**APPLICATION OF AVANT OPERATING, LLC FOR
COMPULSORY POOLING AND APPROVAL OF
NON-STANDARD HORIZONTAL
SPACING UNIT, LEA COUNTY, NEW MEXICO**

CASE NO. 24544

**SECOND AMENDED HEARING PACKET IN SUPPORT
OF THE OBJECTION BY PRIMA EXPLORATION, INC.
TO THE APPLICATION OF AVANT OPERATING, LLC
FOR COMPULSORY POOLING AND APPROVAL OF
A NON-STANDARD HORIZONTAL SPACING UNIT,
LEA COUNTY, NEW MEXICO**

SECOND AMENDED HEARING EXHIBIT PACKET
TABLE OF CONTENTS

Prima Rebuttal Exhibit 1 – Rebuttal to Avant Rebuttal Exhibits G-10, G-12, G-13, G-16

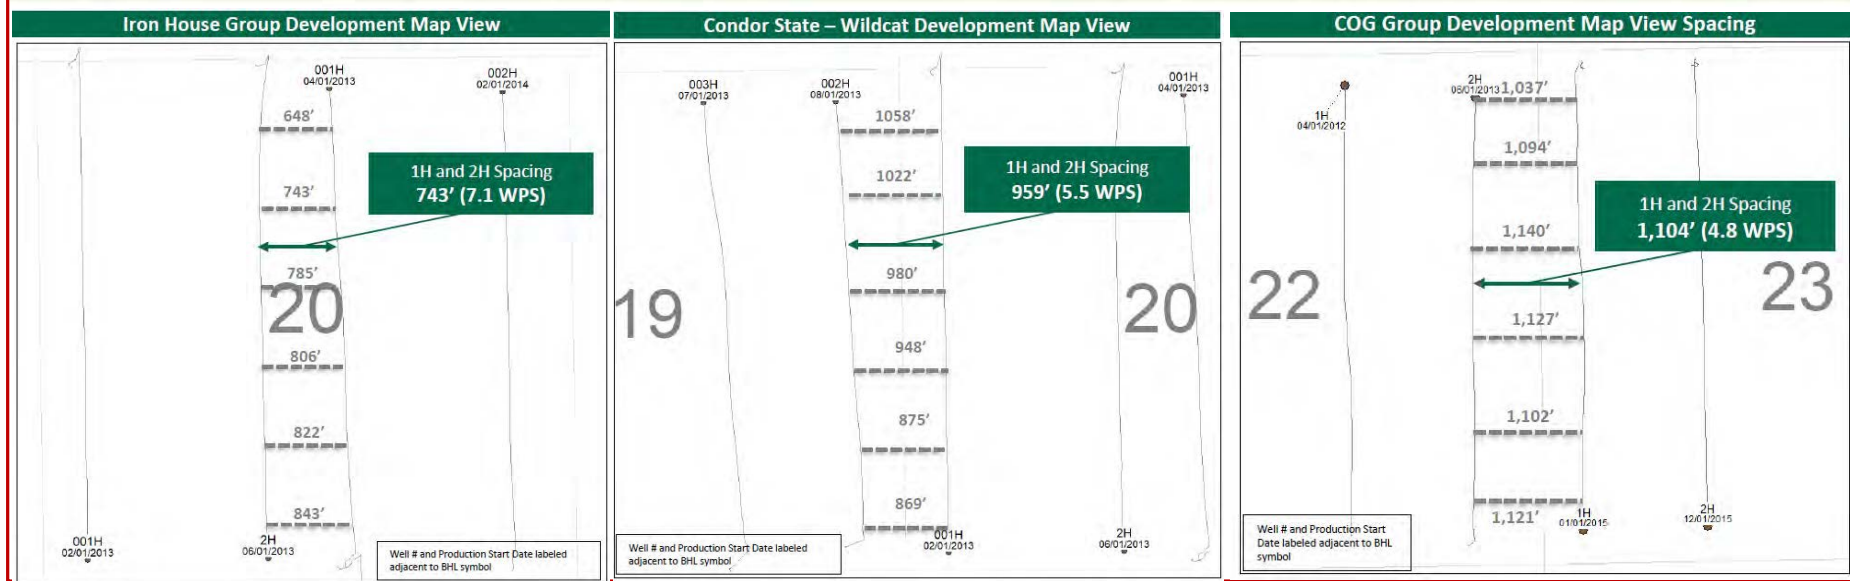
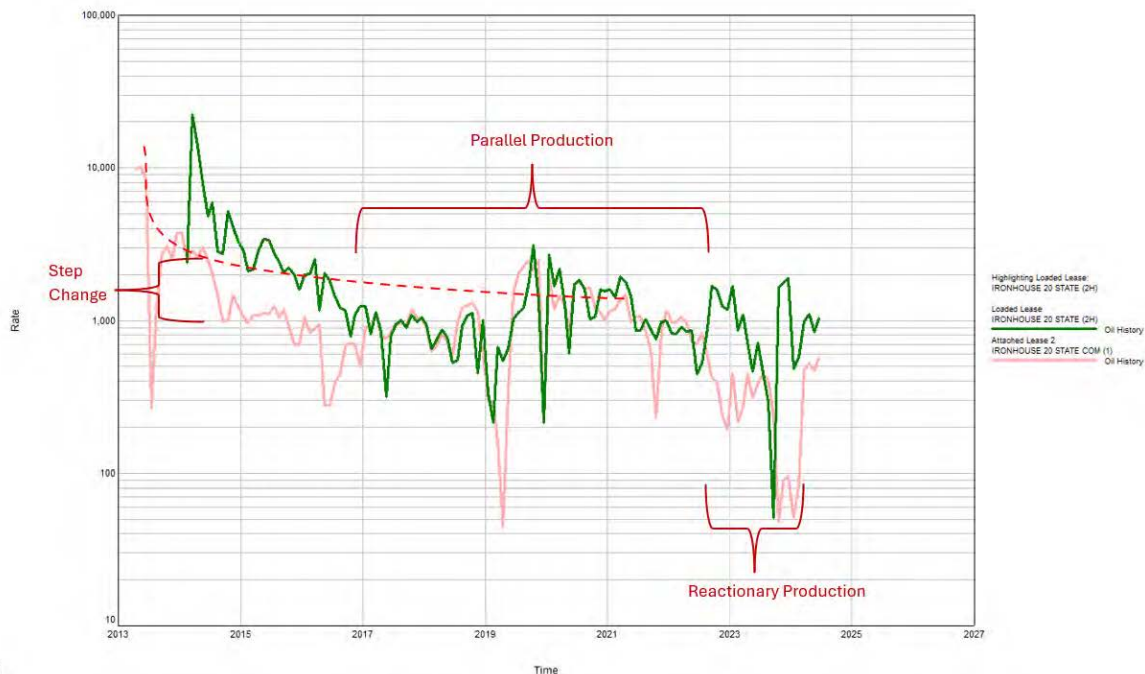
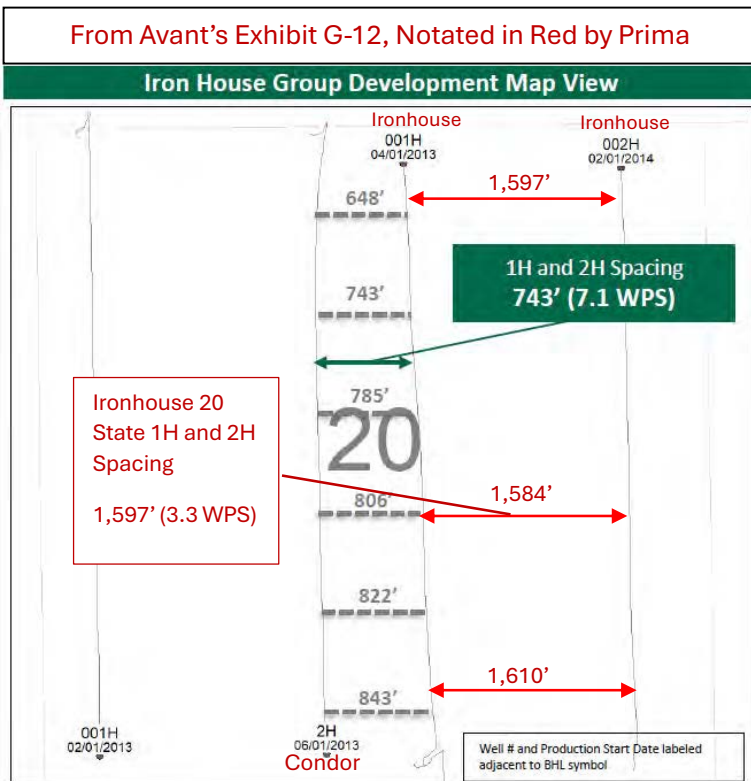
- Though these examples include wells Prima did not present or are incomplete, they are useful to push back on Exhibit G-10’s claims
- In the Summary to Exhibit G-10, Avant argues:
 - 4 WPS is historically normal, and thus Avant’s proposal is normal
 - Greater than 4 WPS is, however, also normal and becoming more normal
- Avant’s conclusion with these examples is that denser than 4 WPS shows interference, and that is not what Avant is advocating for
- This is a direct contradiction to their summary arguments in Exhibit G-10
- None of these arguments by Avant recognize the foundational issue of overdevelopment. Instead, they focus on historical norms
- Just because someone else is throwing money away, doesn’t mean you should too

Prima Rebuttal Exhibit 3 – Rebuttal to Avant Rebuttal Exhibit G-14

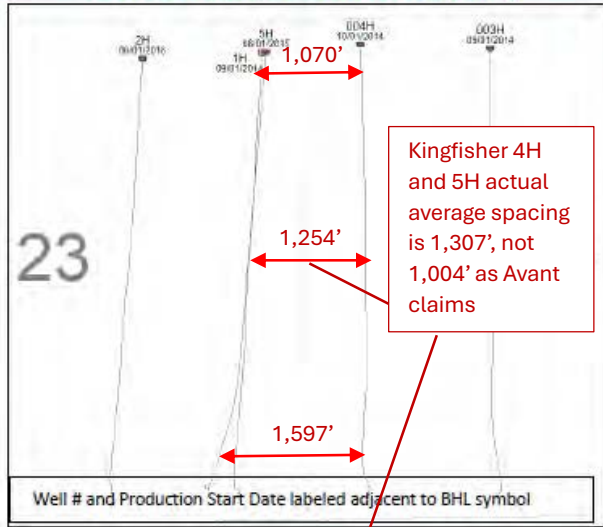
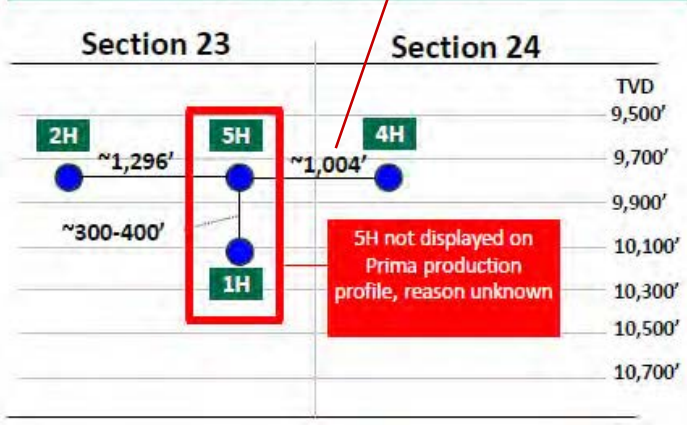
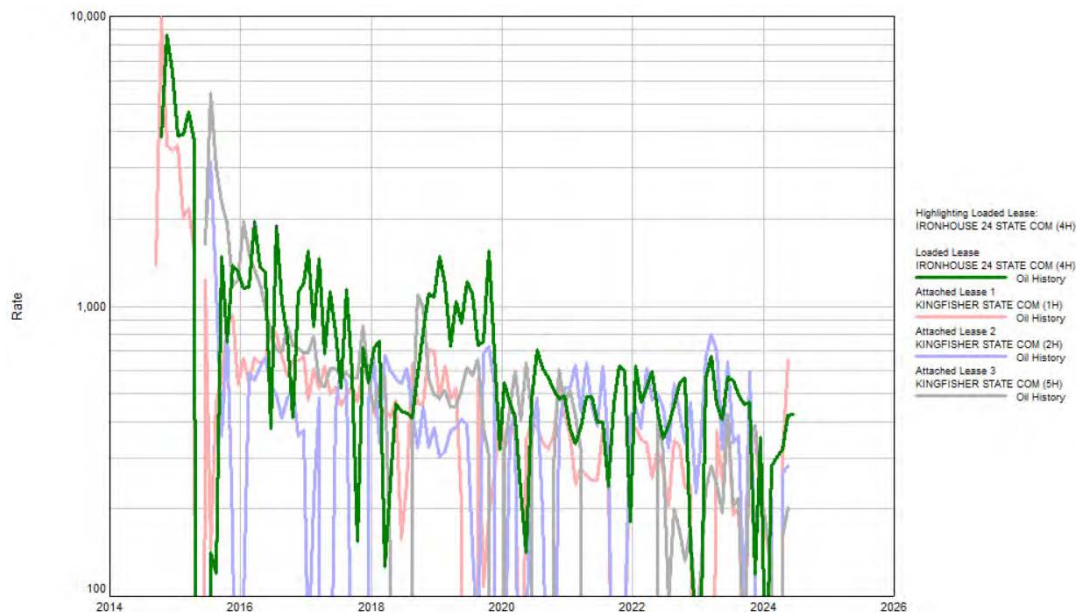
- Avant’s Exhibit G-14 confirms the typo edits that Prima relayed during testimony with their exhibit in regard to well number labels
- In addition, Prima selected the Kingfisher 1H in error, meaning to select the Kingfisher 5H to compare 2BS wells across the board

- That error has been corrected on the next page of Prima’s Rebuttal Exhibit 3
- Avant erroneously claims that the spacing between the Kingfisher 5H and the Ironhouse 24 State 4H is 1,004’

- In fact, the average spacing is approximately 1,307’
- It is general practice to give directional drillers an east-west window to drill in
- Prima’s typical window is 100’, 50’ to either side of the planned wellbore

- Between the 2H and 5H(approximately 1,296’) and the 5H and 4H, the well spacing is very much within standard directional windows for horizontal wells for a 4 WPS spacing of roughly 1,320’ between wells

- Thus, comparing these laterals as like-development to Avant’s proposal is quite valid

Prima Rebuttal Exhibit 3 Continued – Rebuttal to Avant Rebuttal Exhibit G-14

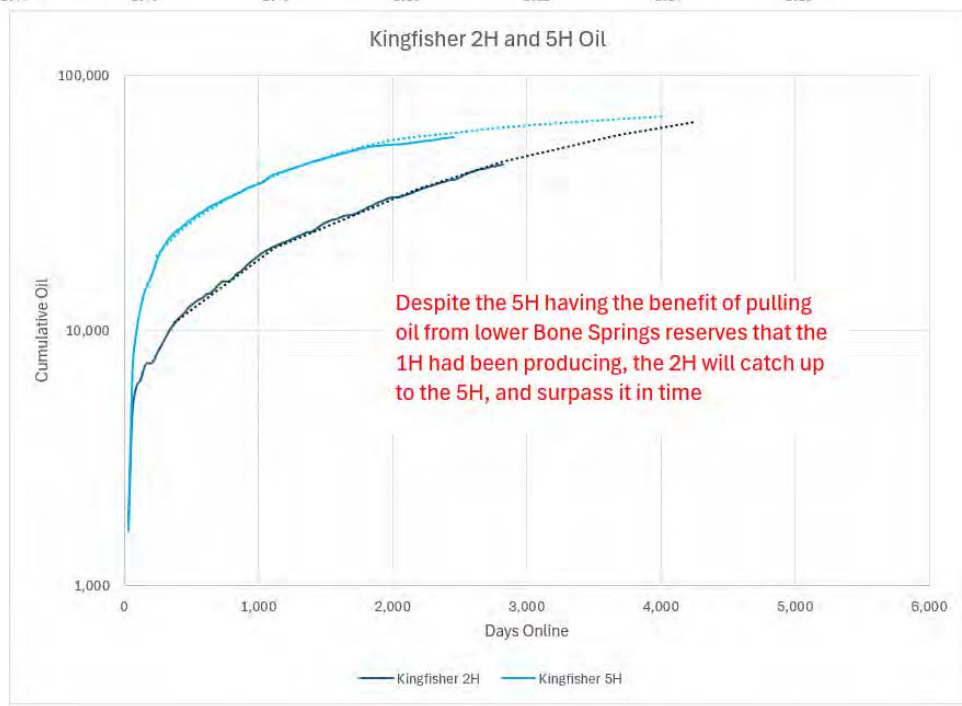
When looking at the correct wells production, the Kingfisher 5H (interior well excluded in Prima analysis) is outperforming the edge well in the package indicating adequate well spacing

- Correcting the overlay with the inclusion of the Kingfisher 5H shows:
 - Different benches communicate
 - Wine rack unlikely to prevent communication
 - 1,320' spacing immediately interferes
- The Kingfisher 5H had such a large impact on the Kingfisher 1H, that it is clear it pulled much of the lower bench's reserves, improving its performance at the expense of the 1H
- Still, the Kingfisher 2H projects to catch and surpass the Kingfisher 5H, despite Avant's claims

Prima Rebuttal Exhibit 4 – Rebuttal to Avant Rebuttal Exhibit G-15

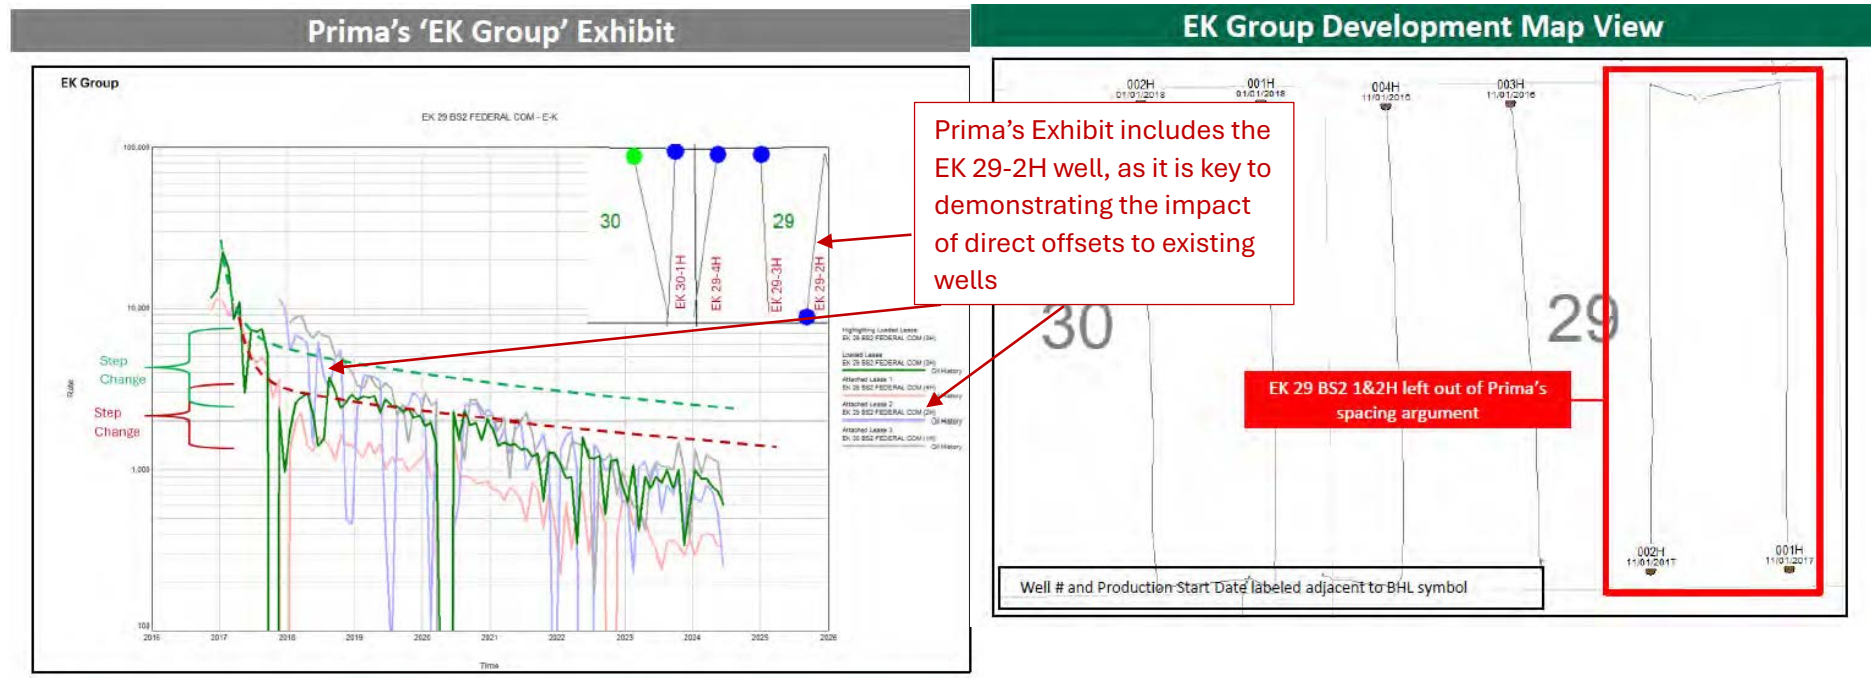
- Avant claims multiple times that Prima did not include the EK 29-2H well
- This is erroneous
- The Ek 29-2H well is key in showing the impact of new wells impact on existing wells within their drainage area
- As is clearly demonstrated, the EK 29-2H well had a significant impact on the EK 29-3H well, and will accumulate much lower reserves due to:
 - Being drilled into a significantly drained area with a year of depletion
 - Being bound then on both sides for its entire lifespan

Prima Rebuttal Exhibit 4 Continued – Rebuttal to Avant Rebuttal Exhibit G-15

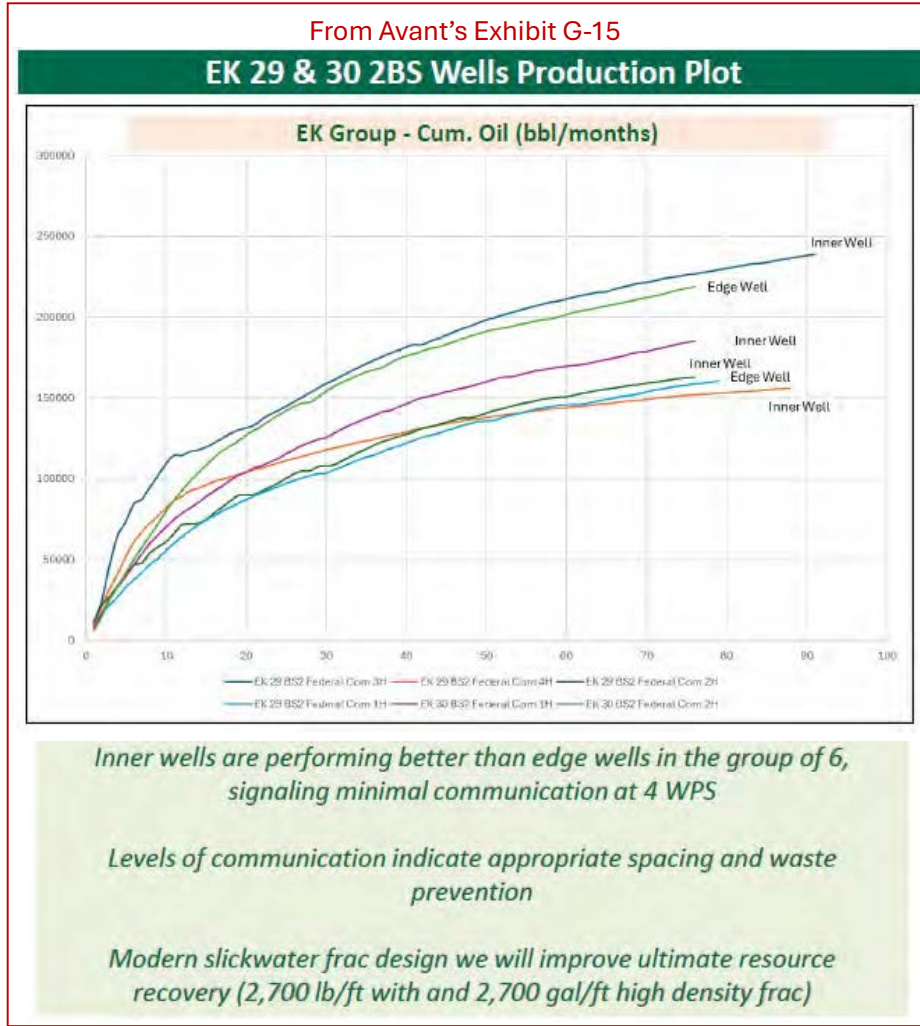
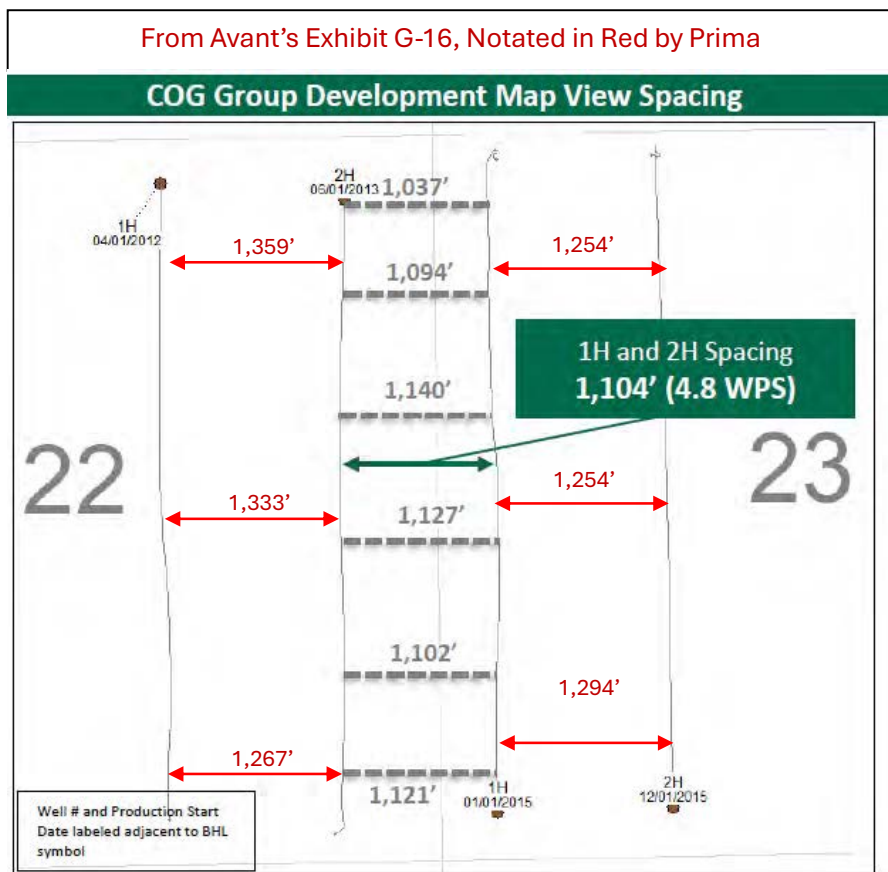
- The EK wells are unique, in that the inner wells were actually the original wells
- A full year of reduced interference allowed them to drain significant reserves prior to the offsets being drilled
- The EK 29-3H accumulated 114 MBO in its first year, prior to the offset EK 29-2H impacting it
- That amounts to just under half the oil it has made in its 8 year life(238 MBO total)!
- The fact that it has taken 7 years to double the production from year 1 for the EK 29-3H is NOT a vindication for this well spacing. Quite the opposite
- No evidence of “appropriate spacing and waste prevention” is given
- No metrics for determining “appropriate spacing and waste prevention” are given
- Well spacing density consistently shows significant communication, regardless of the completion technique and intensity

Prima Rebuttal Exhibit 5 – Rebuttal to Avant Rebuttal Exhibit G-16

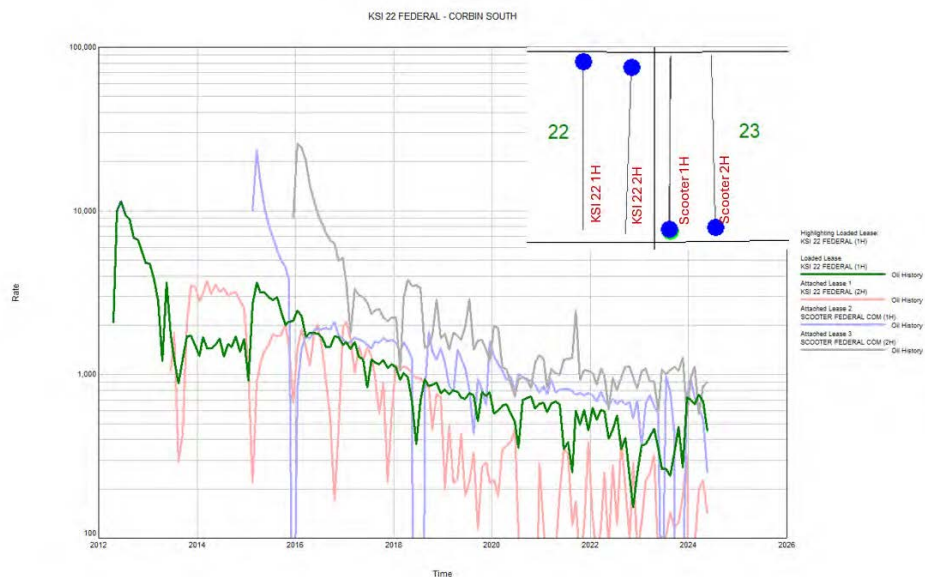
- Avant claims Prima is not representing 4 WPS
- The average spacing for the KSI 1H and 2H wells is ~1,320', which is exactly 4 WPS
- The average spacing of the Scooter 1H and 2H wells is ~1,267', which is very near the wellbore window for 1,320' spacing
- With that, each of the 4 wells has an ~ 4 WPS offset on one side
- Avant claims the KSI 1H took a frac hit then recovered... that's a nearly 2 year "frac hit" that ignores the obvious interference and reactions to the KSI 2H
- The recent uptick was short-lived and it's back on decline

Prima Rebuttal Exhibit 6 – Rebuttal to Avant Rebuttal Exhibit G-17

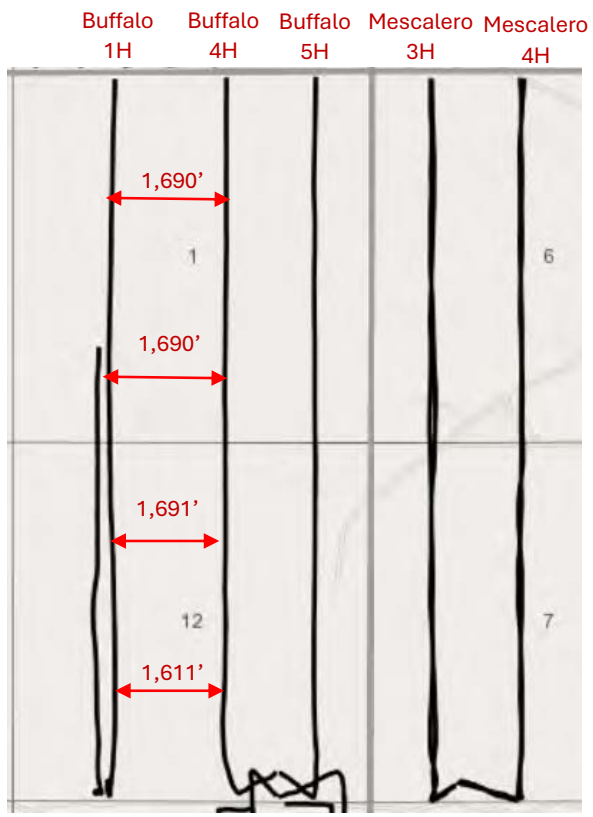
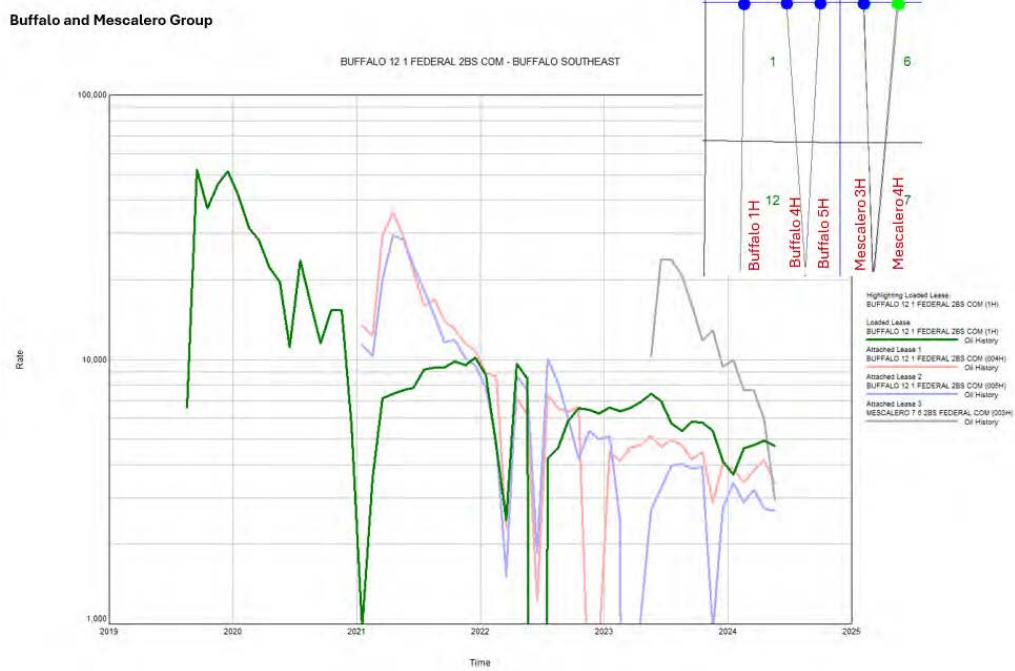
- The Buffalo 1H is approximately 1,671 ft offset to the Buffalo 4H, well beyond Avant's proposed 1,320'
- Despite this, interference was immediate
- Avant just argued in exhibit after exhibit that interference closer than 1,320' is irrelevant to their plans

- Avant just argued in exhibit after exhibit that interference at their 1,320' plans has numerous excuses
- Now, after all that, Avant says that density doesn't matter, because interference is a good thing?

- If "interference among offset wells is indicative of sufficient well density & completion size", then why not propose 20 wells per bench? Surely 264' spacing with 20 wells would result in "interference among offset wells", which would be "indicative of sufficient well density & completion size"

- In reality, development that prevents waste minimizes interference, achieving it only towards the very end of the life of the wells, when the boundary of drainage areas slightly overlap
